Village of Arlington Heights  
Plan Commission  
Virtual Meeting  
July 22, 2020  
7:30 PM

- A. Mariano's Gas Station - 406 E. Northwest Hwy. - PC#20-009  
Special Use Permit for Auto Service Station, Variations

**Project Number:** PC 20-009  
**Project Title:** Mariano's Gas Station  
**Address:** 406 E. Northwest Highway  
**PIN:** 03-29-351-009

**To:** Plan Commission  
**Prepared By:** Sam Hubbard, Development Planner  
**Meeting Date:** July 22, 2020  
**Date Prepared:** July 17, 2020

## DIMENSION CONTROL SITE PLAN

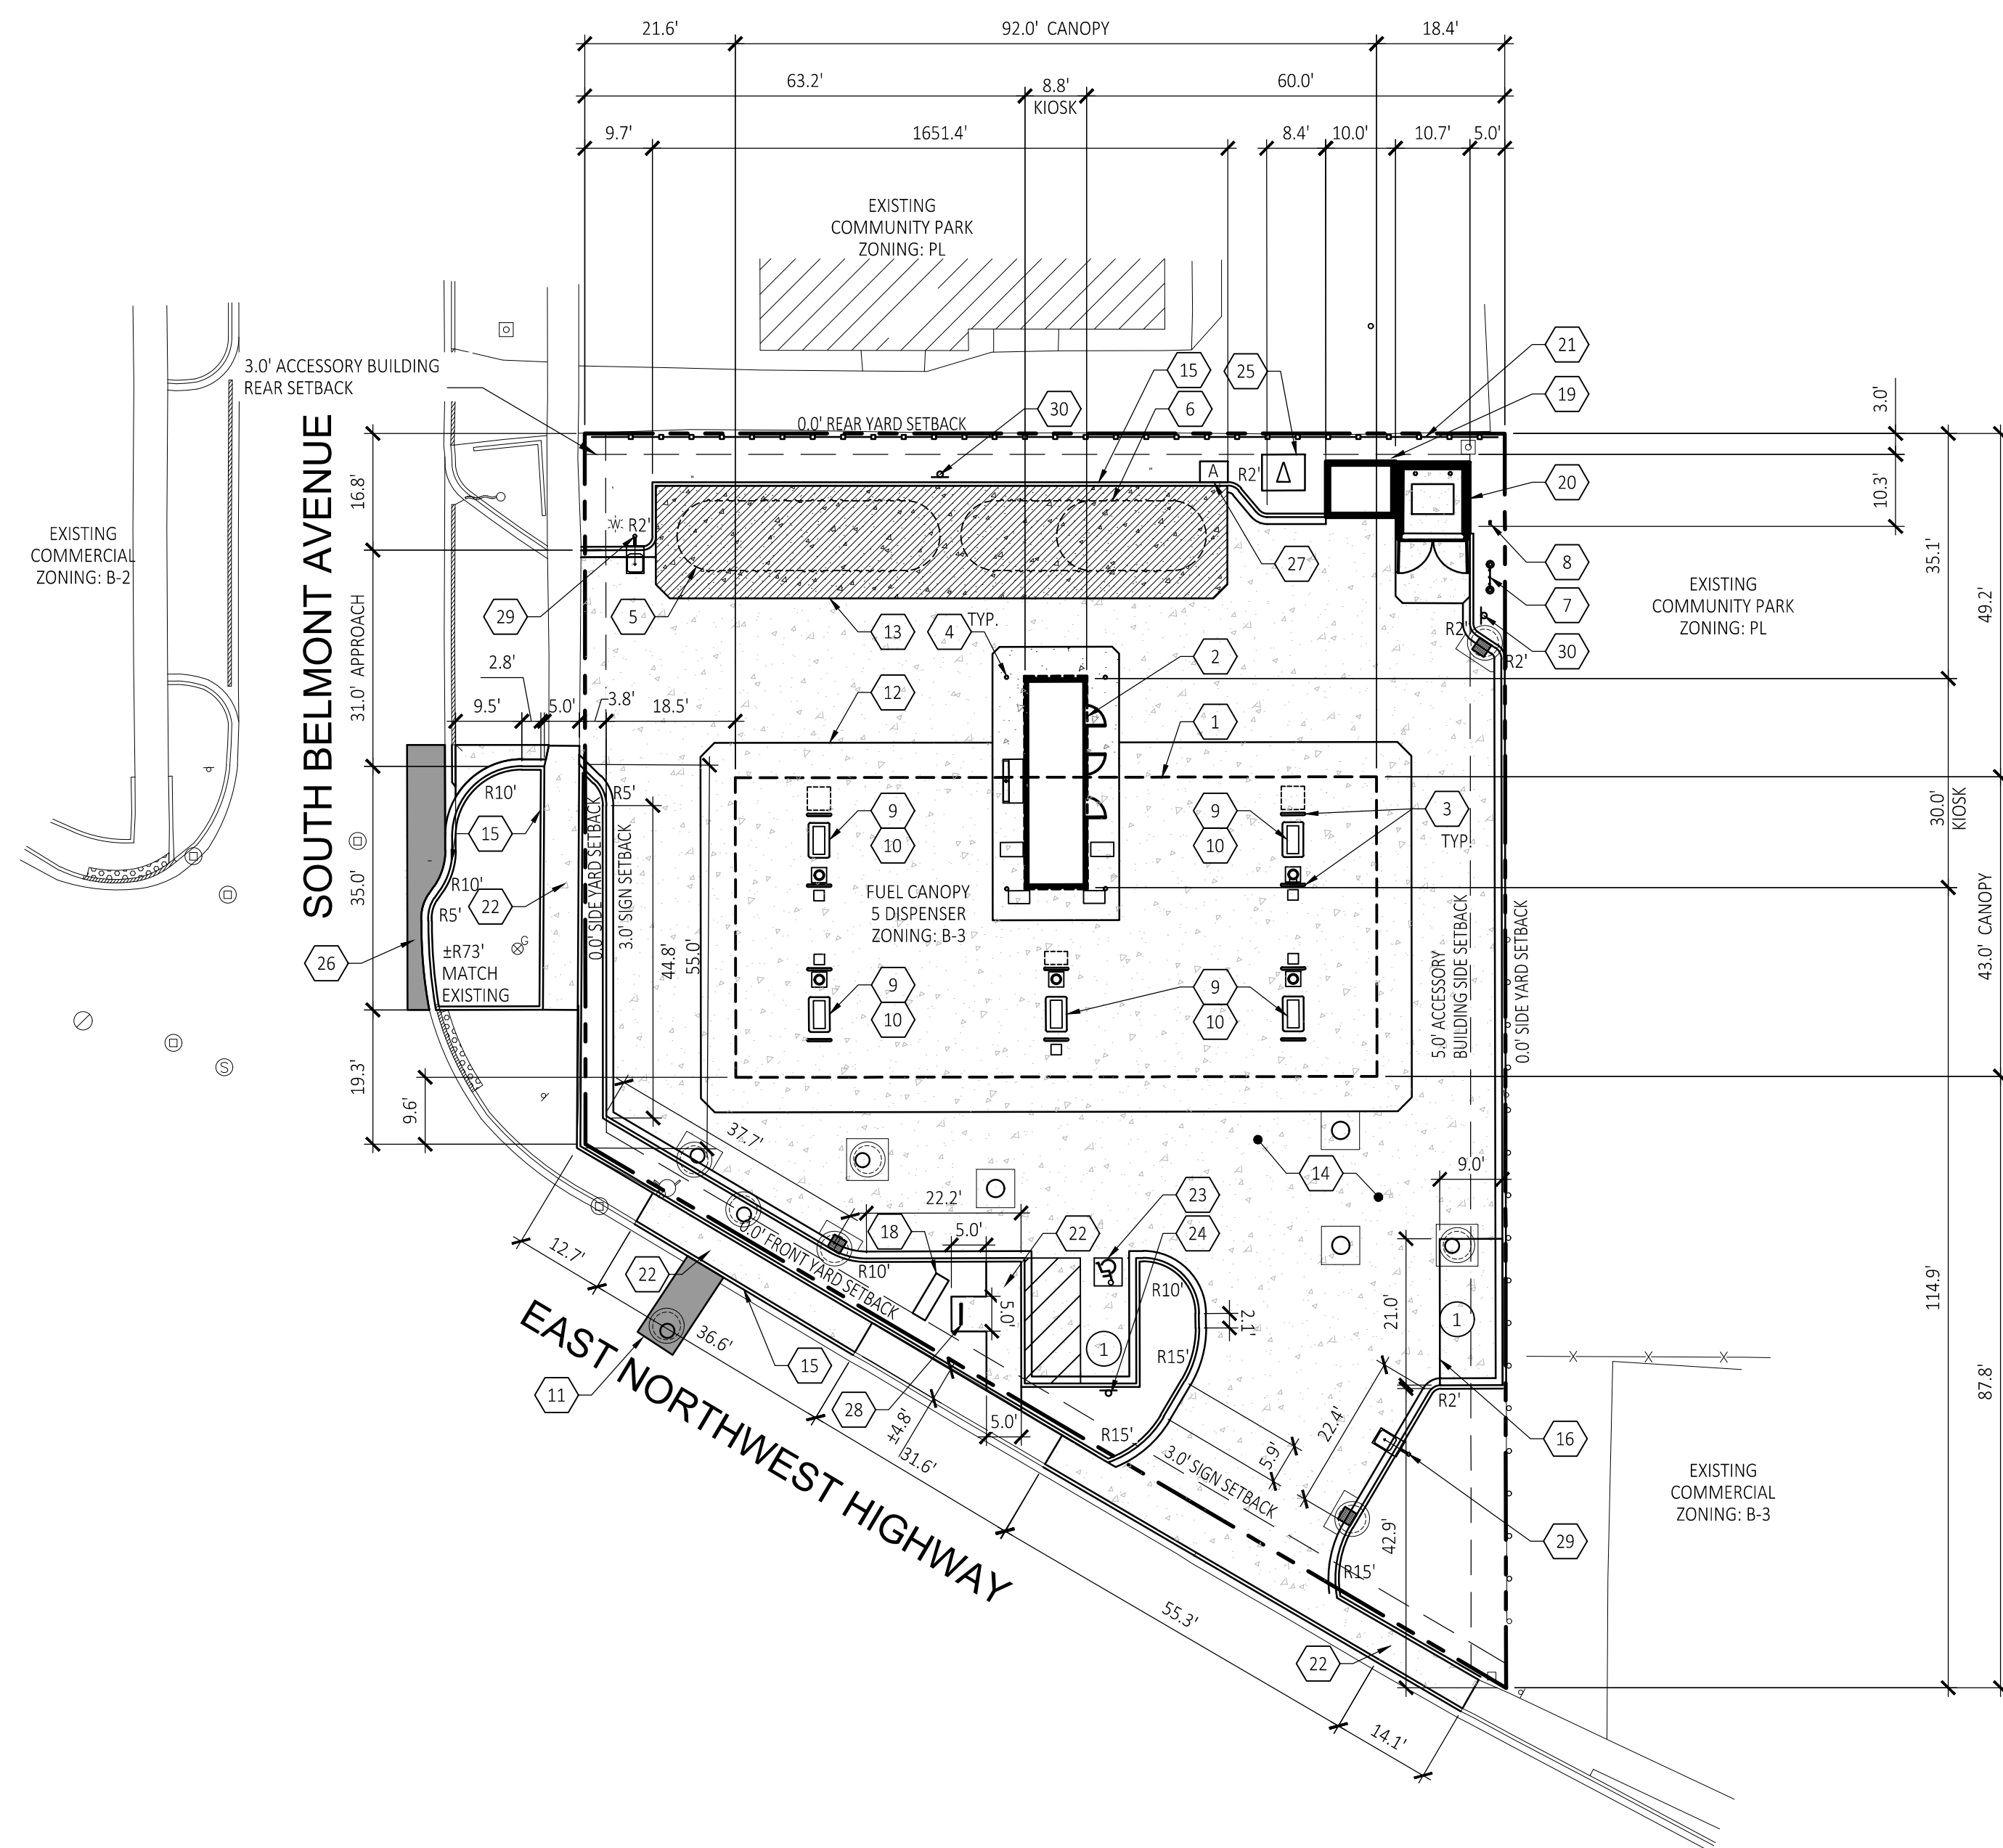
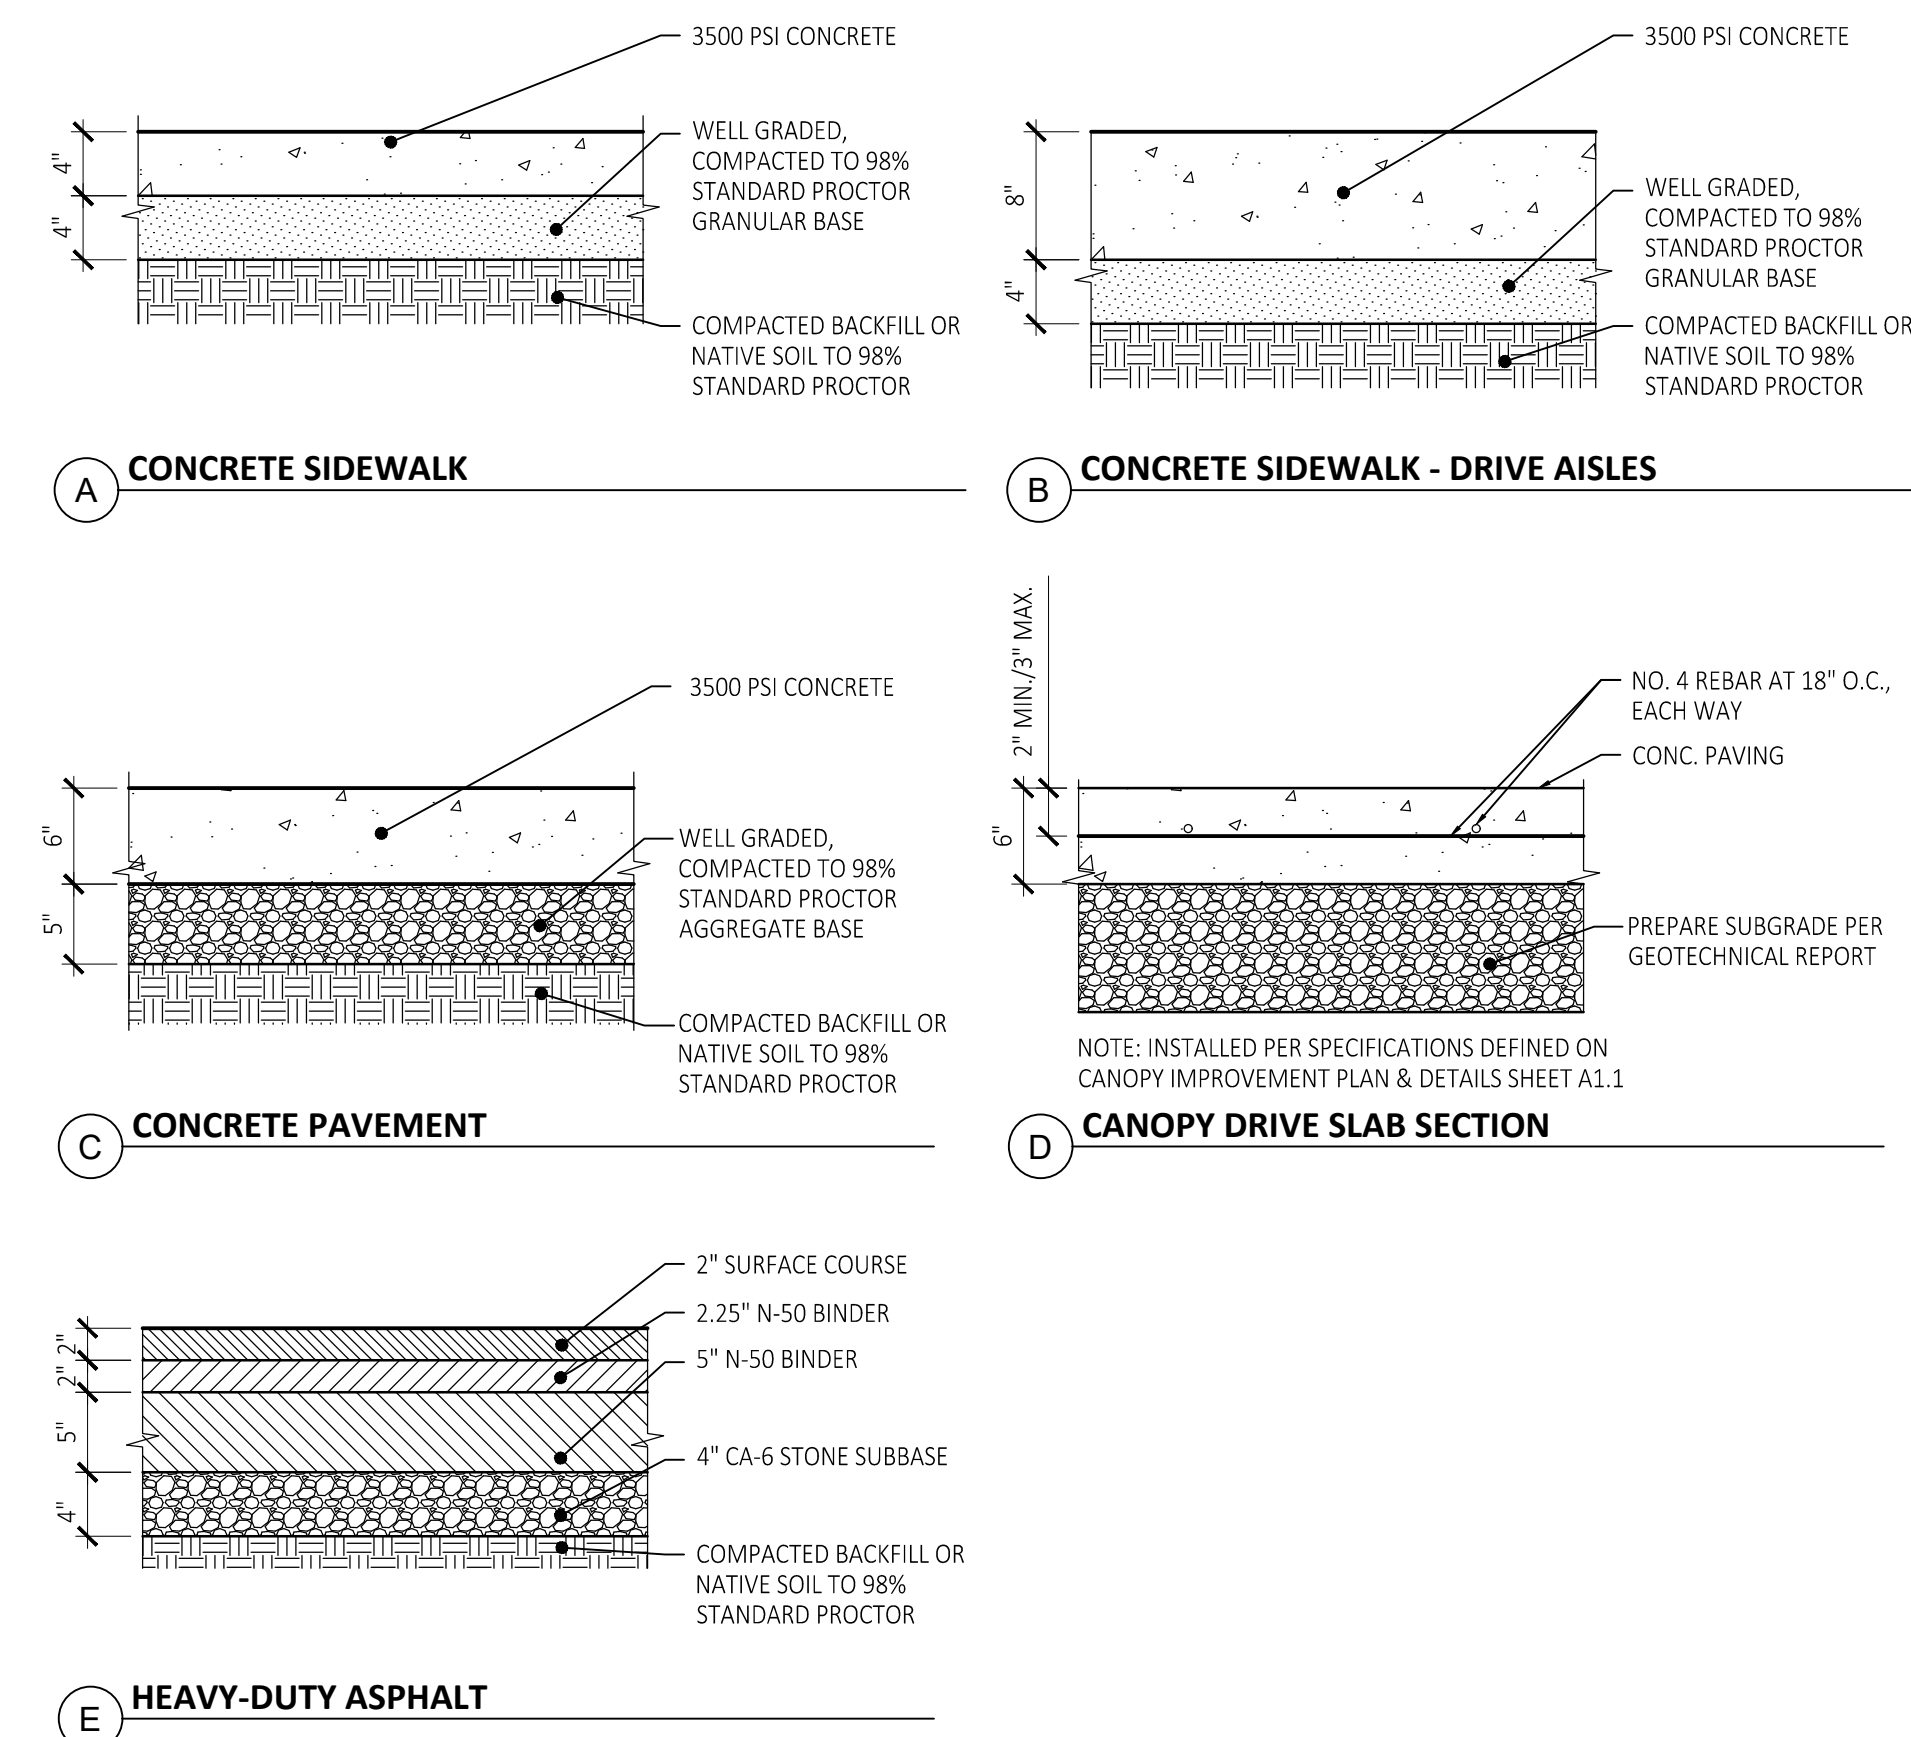
**The tank vent stack has been moved to the northeast corner of the property. See sheet C1.20.**
17. Please add a note to the plan outlining where the two required bike parking spaces will be located.

**A bike rack is now shown on sheet C1.20, see keynote 28.**
18. Please include a note on the site plan that calls out the square footage of the kiosk and the canopy overhead.

**The existing ground sign will not be re-used, and a new monument sign is proposed further to the east. See sheet C1.20 for new monument location.**
20. Landscaping within the required 12 foot clear visibility triangle at the street intersection (measured along the property lines at the southwest corner of the site) is limited to a maximum of 18 inches in height.

## L1.20

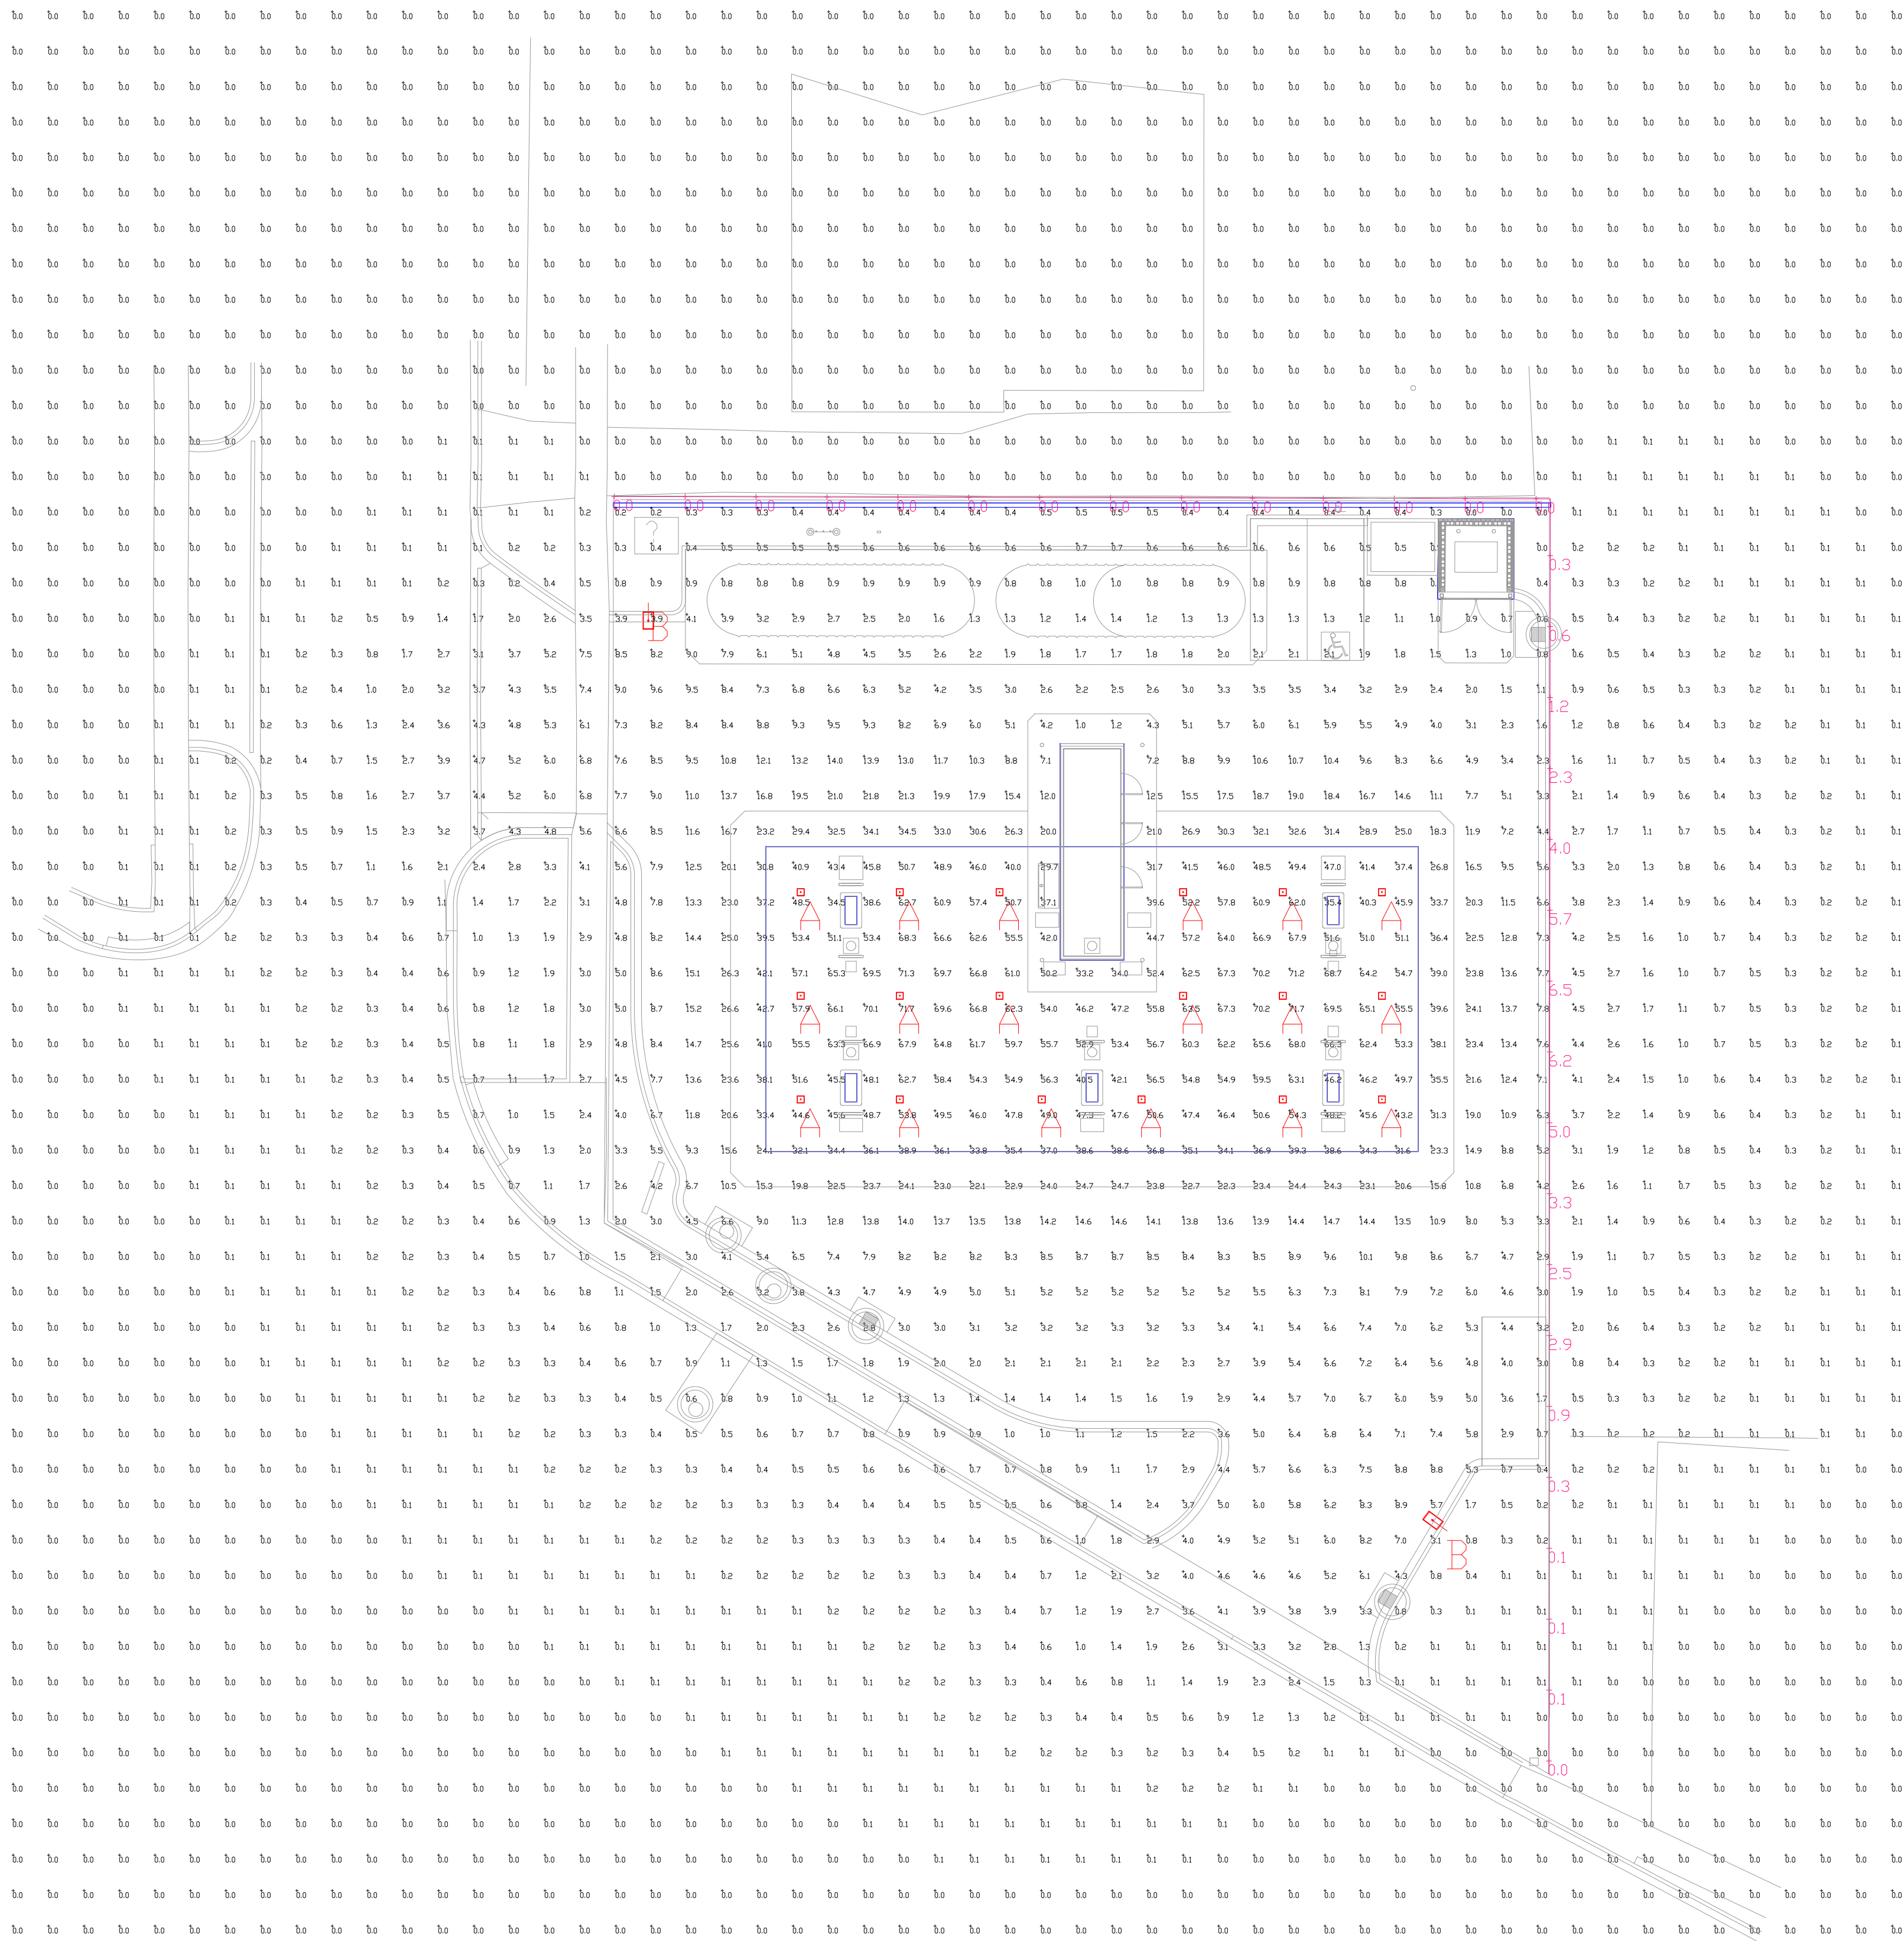
**The arborvitae type has been revised to provide a solid screen that is higher than 15' at mature height, see sheet L1.20.**
  - h. Requirement that the buyer make every effort possible to sell, give or preserve the rocket to the historical society. (Arlington Heights Art Commission)

**Acknowledged. All landscaping within the 12' clear vision triangle is less than 18" tall, see sheet L1.20.**
21. The location of the proposed transformer is not appropriately located so close to the public sidewalk. Please re-evaluate the proposed location and, if feasible, relocate to the northeast corner of the site

**The size of the proposed shrubs along the ROW has been revised to 3', see sheet L1.20.**
2. It is recommended that two additional shade trees be provided along Northwest Highway. In addition, increase the size of the proposed Red Maple located in the southeast corner.

**Two additional shade trees have been provided along Northwest Highway. The size of the proposed red maple has also been increased to 10', see sheet L1.20.**
